NORWALK LA MIRADA UNIFIED SCHOOL DISTRICT
LA MIRADA HIGH SCHOOL NEW FOOTBALL STADIUM PROJECT
13520 ADELA DRIVE, LA MIRADA, CA 90638

ADDENDUM 1

FLOOR PLANS
BUILDING "W" -
LIGHTING & POWER

E7.03

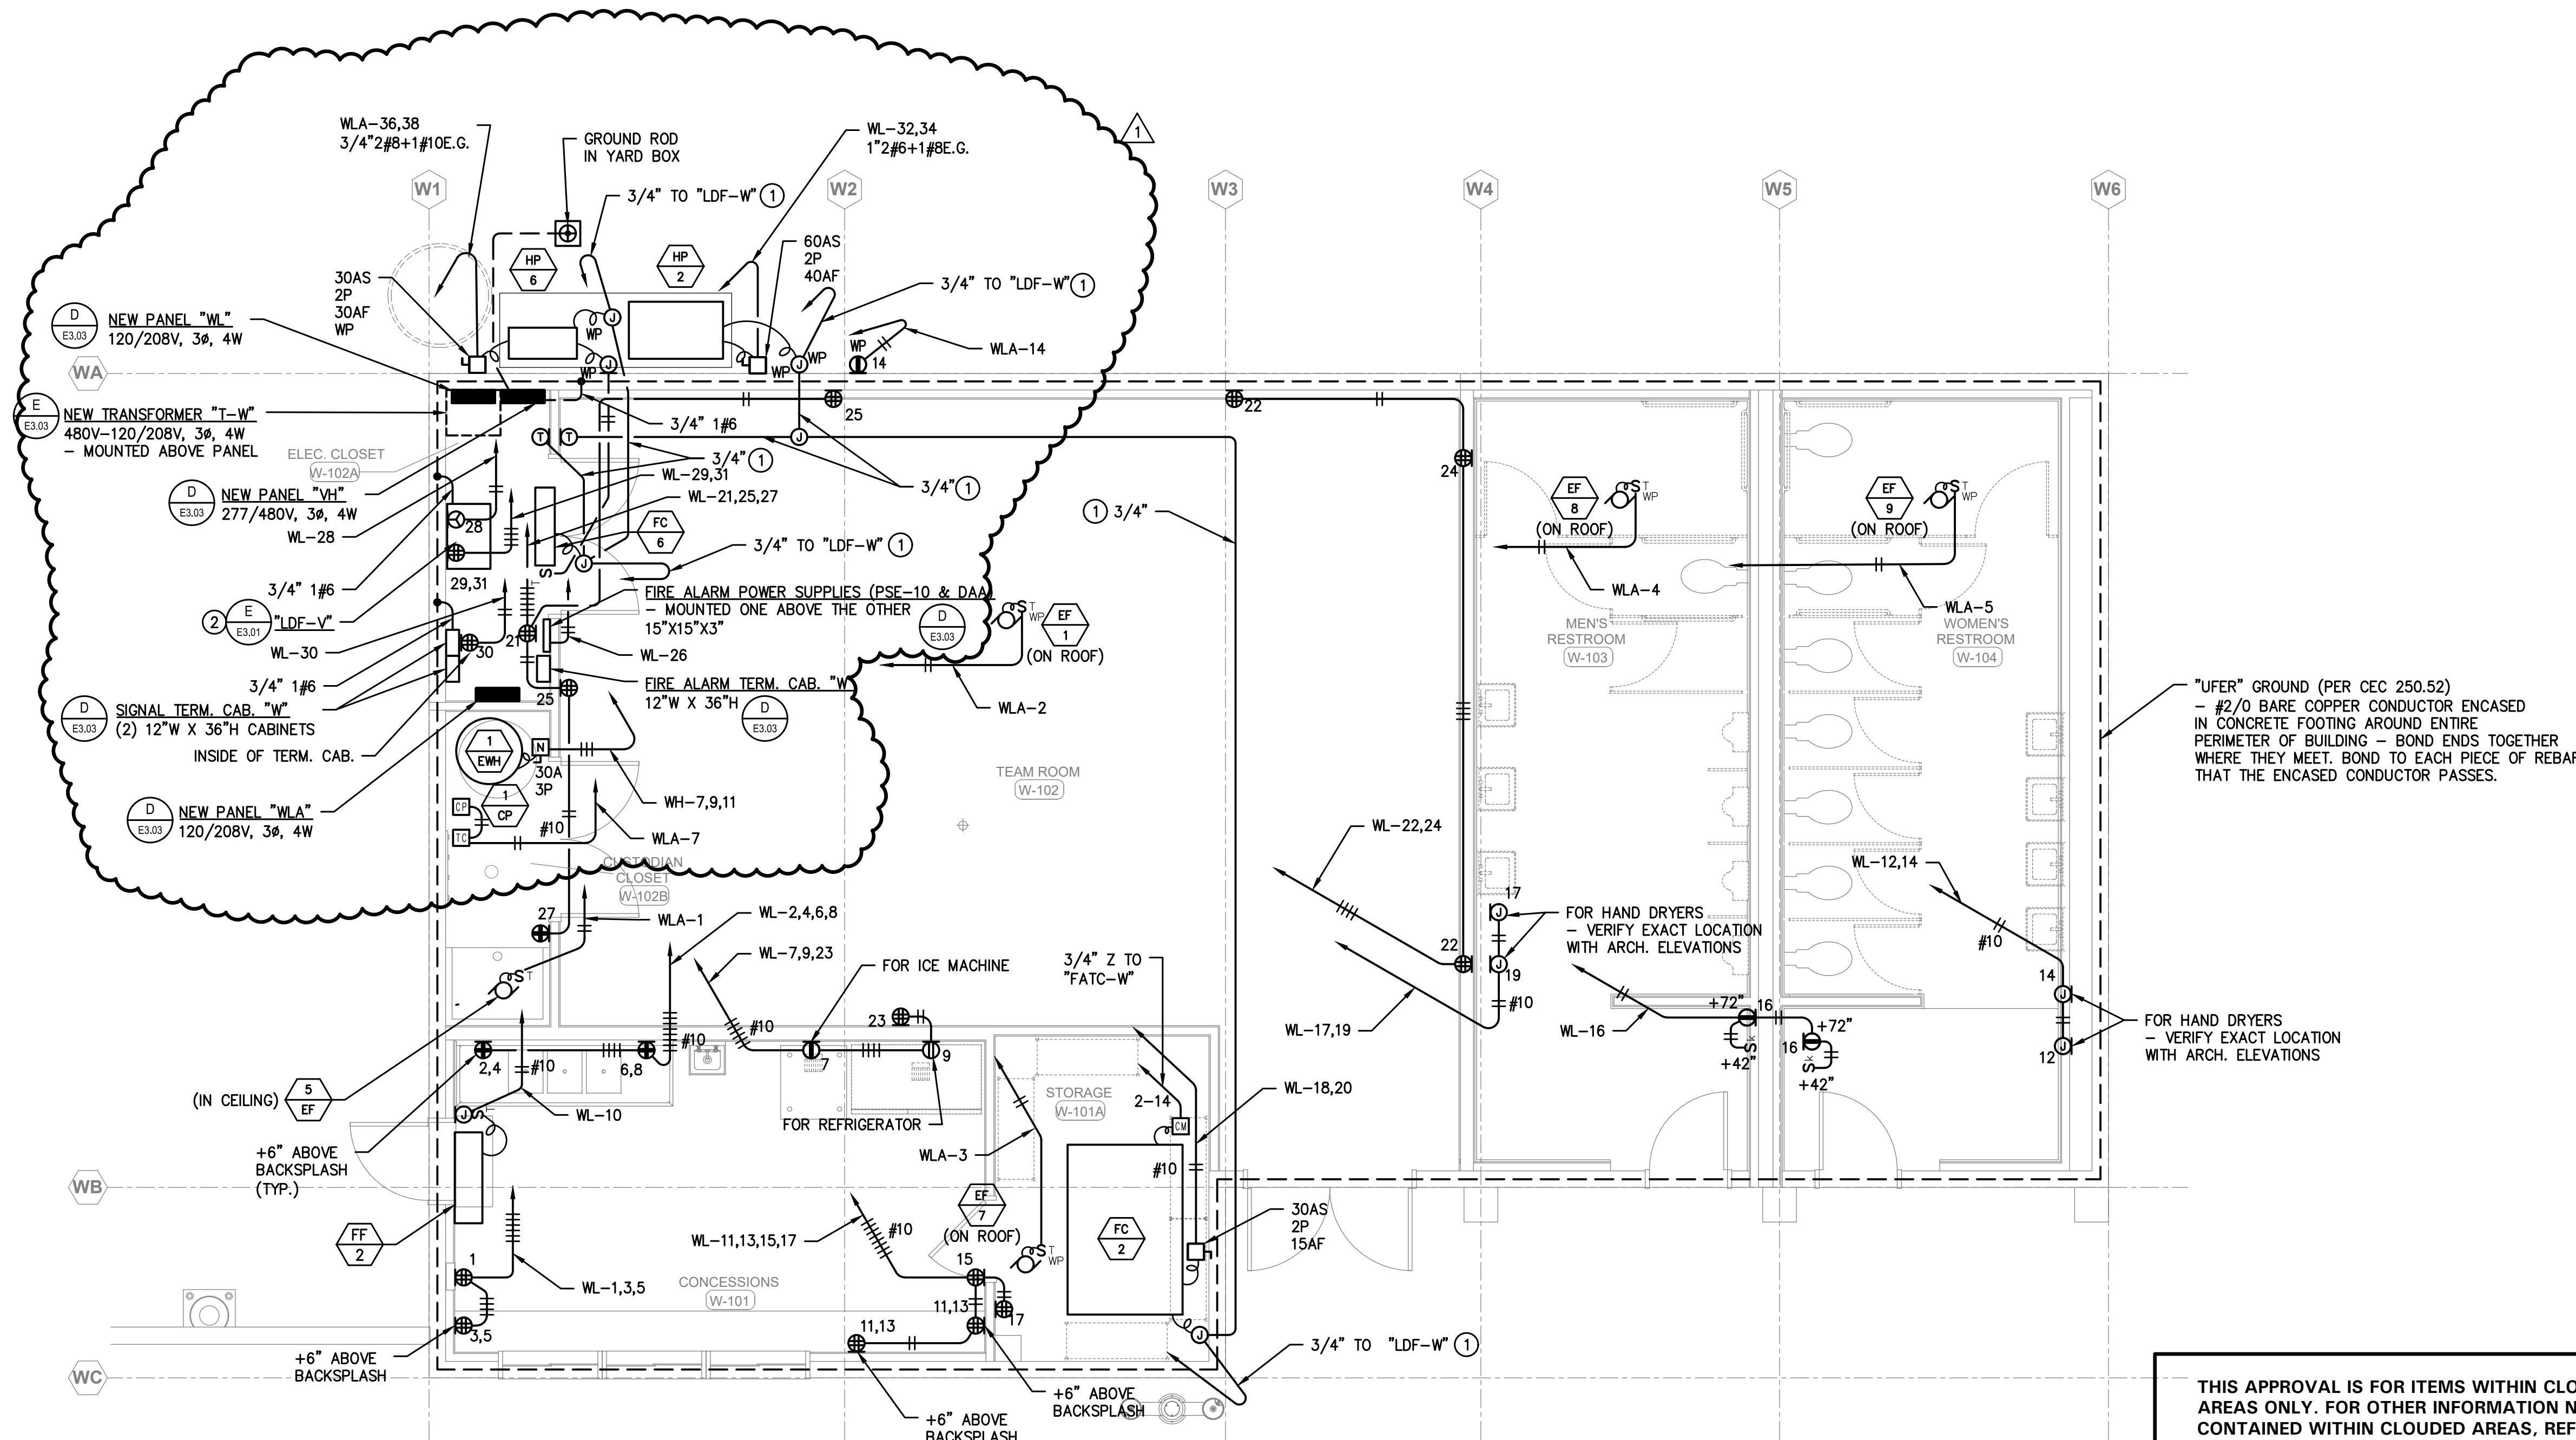
THIS APPROVAL IS FOR ITEMS WITHIN CLOUDED AREAS ONLY. FOR OTHER INFORMATION NOT CONTAINED WITHIN CLOUDED AREAS, REFER TO ORIGINAL DSA APPROVED PLANS.
